**MALCOLM SCOTT** B.A. & D.U.R.P. (UNE) M.P.I.A.  
**CONSULTANT TOWN PLANNER**

**Re Independent Town Planning Assessment  
Concept Development Application (DA) No. 2015/96  
Lot 163 DP 831052, Lot 276 DP 755624, Lot 277 DP 755624, Crown Foreshore  
Reserve, Crown road reserve between Lot 276 DP 755624 and Lot 163 DP  
831052 and Iron Gates Dr road reserve.  
240 Iron Gates Dr. Evans Head NSW**

This letter report is a town planning assessment of DA No. 2015/96 and is set out in the following manner.

**Map No. 6 Vegetation communities (Planit Consulting, August 2014 as amended by JWA Pty Ltd, July 2019)**

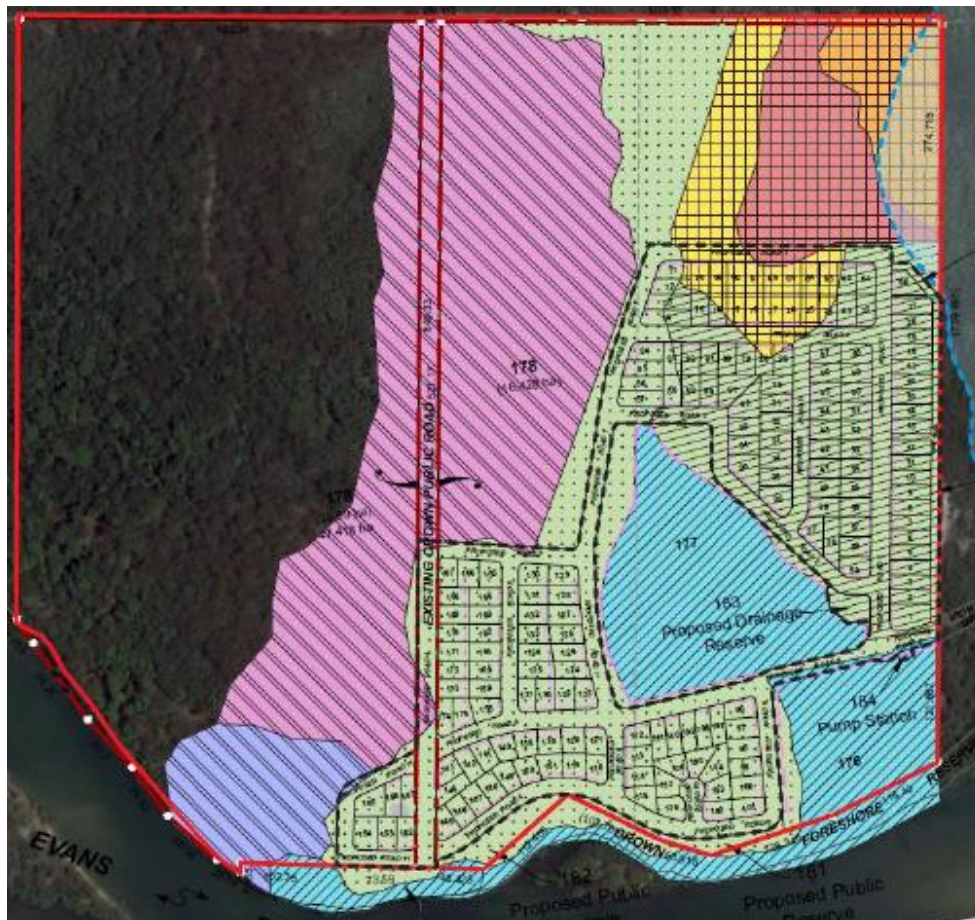
The *Terrestrial Flora and Fauna Assessment Report* identifies 4 broad vegetation categories on the land comprising:

**Map No. 7 Biodiversity Values Map (Biodiversity Values Map and Threshold Tool)**

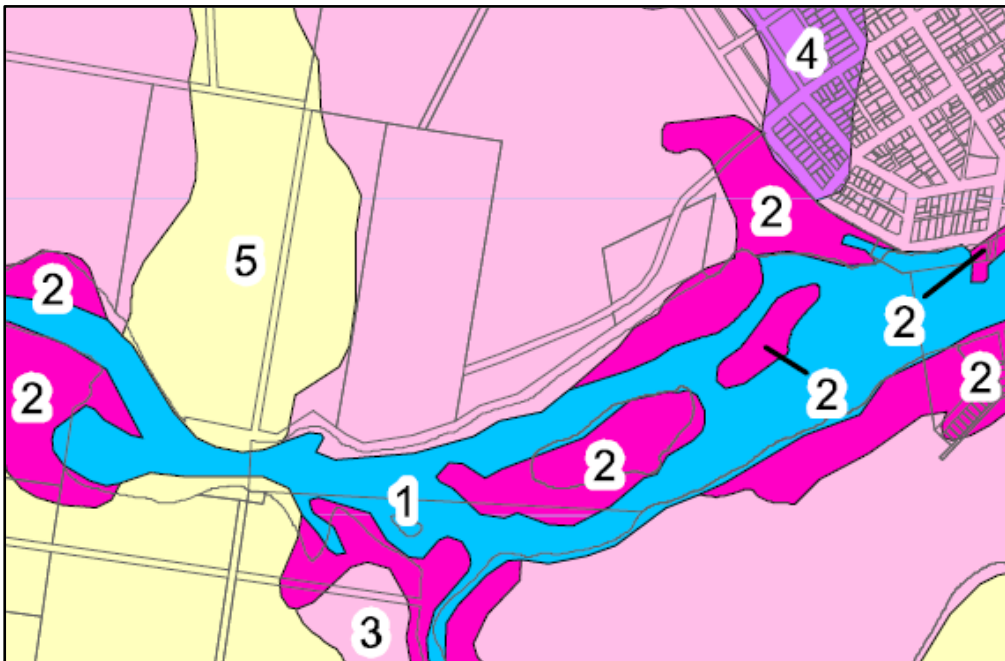
The Biodiversity Values Map and Threshold Tool for *State Environmental Planning Policy (Vegetation in Non-Rural Areas) 2017* (now Chapter 2 of *State Environmental Planning Policy (Biodiversity and Conservation) 2021*) and *Biodiversity Conservation Regulation 2017* shows that a north-eastern part of Lot 277 DP 755624 is mapped as having 'biodiversity value'. Refer to **Map No. 7**.
